PLANNING, ZONING, & BUILDING DEPARTMENT
PZ&B Staff Combination Memorandum: Town Council and Architectural Commission

SUBJECT: ARC-24-038 (ZON-24-045) 207 PENDLETON AVE (COMBO)

MEETING: APRIL 24, 2024, ARCOM
MAY 15, 2024, TC

The applicant has submitted plans, entitled "ENTRY RENOVATION 207 PENDLETON AVENUE", as prepared by **Kirchhoff & Associates Architects**, date stamped by the Town, April 8, 2024.

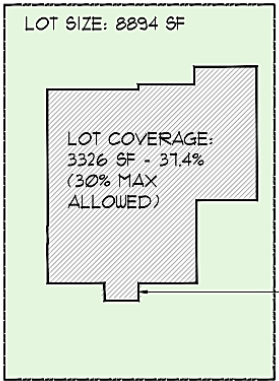
VARIANCE REQUIRED
 SECTION 134-893 (11) A REQUEST FOR A VARIANCE TO ALLOW THE FRONT ENTRY ADDITION TO HAVE A 37.4% LOT COVERAGE IN LIEU OF THE 37.1% EXISTING AND THE 30.0% MAXIMUM ALLOWABLE.

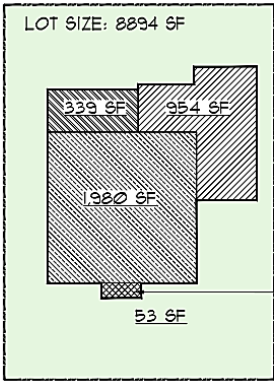
ADDED COVERAGE:
24 SF

VARIANCE REQUIRED
 SECTION 134-893 (13) A REQUEST FOR A VARIANCE TO ALLOW THE FRONT ENTRY ADDITION TO HAVE A CUBIC CONTENT RATIO (CCR) OF 4.52 IN LIEU OF THE 4.51 EXISTING AND THE 4.31 MAXIMUM ALLOWABLE.

ADDED CUBIC CONTENT:
141 CF
